Item Name: Replacement Skidtube.High Gear with Standard Wearplates Fits LH or RH

DRAWING NO. D2650	TITLE 206/407 SKIDTUBE ASSEMBLIES	REV. F	DART AEROSPACE LTD ENGINEERING ORDER		D.E.O. NO. D2650-F-1	SHEET NO. SHEET 1 OF 1	SCALE NTS
DRAWN <i>[Signature]</i>	CHECKED A.P.	MFG. APPR. <i>[Signature]</i>	APPROVED <i>[Signature]</i>		DE APPR. <i>[Signature]</i>		
DATE 12.10.12	DATE 12.10.22	DATE 12.10.22	DATE 12.10.22		DATE 12.10.22

CHANGE C'BORED WELDED CROSSBOLT SPACERS TO SWAGED SPACERS

DETAIL B

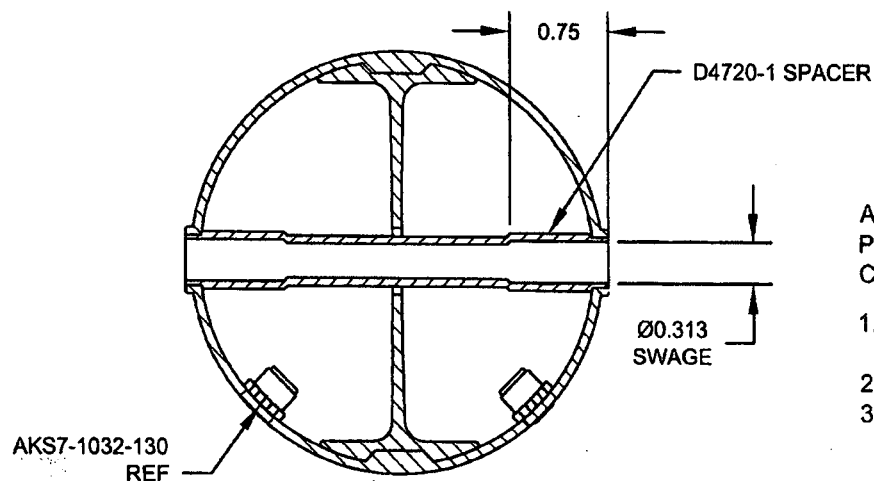
ADD DETAIL G BELOW, WHICH IS THE SAME SECTION VIEW AS DETAIL D OF DWG.
C'BORED HOLES ARE **NOW SWAGED** PER DETAIL G BELOW. FOR THE Ø0.375 HOLE THAT IS NOT C'BORED, WELD PER DETAIL D OF DWG (SEE AMENDED DETAIL B FOR REFERENCE).

D2649 SPACER,
WELD PER DETAIL D OF DWG
BUT DO NOT C'BORE

AMENDMENT TO DETAIL B
NOT TO SCALE
